DRAINAGE AND TRANSPORTATION INFORMATION SHEET

RE: **Lot 8 Block 4 Unit 18 Volcano Cliffs**
6605 Cuervo Pl NW
Grading and Drainage Plan
Engineers Stamp Date 5/14/15 (D10D003J8)

Based upon the information provided in your submittal received 5/15/15, this plan cannot be approved for Grading Permit and Building Permit until the following comments are addressed.

GRADING & DRAINAGE PLAN
6605 Cuervo Place, NW
LOT 8, BLOCK 4, UNIT 18 VCS
 Sheet 2 of 2

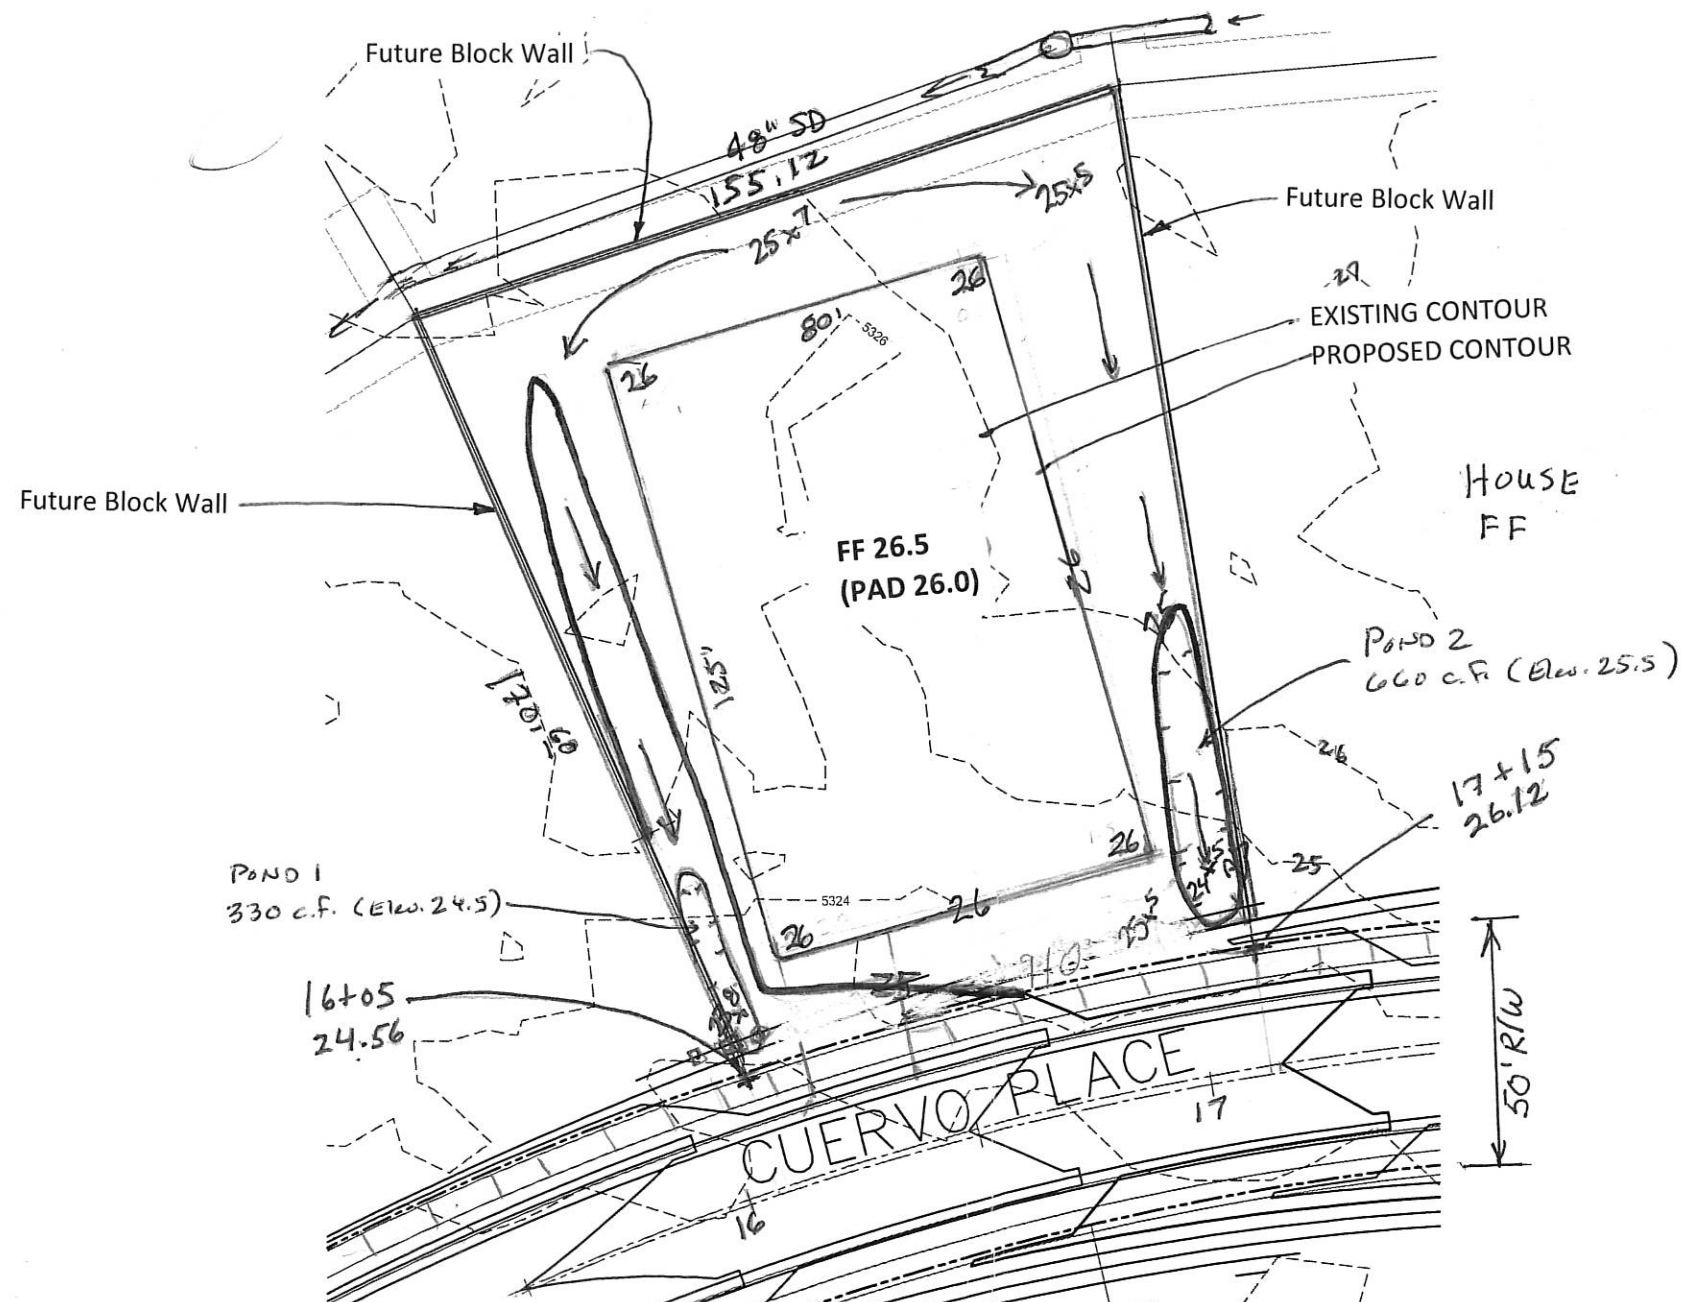
- Provide pond bottoms and WSE. / Done 6-17-15
- Provide pond volumes.
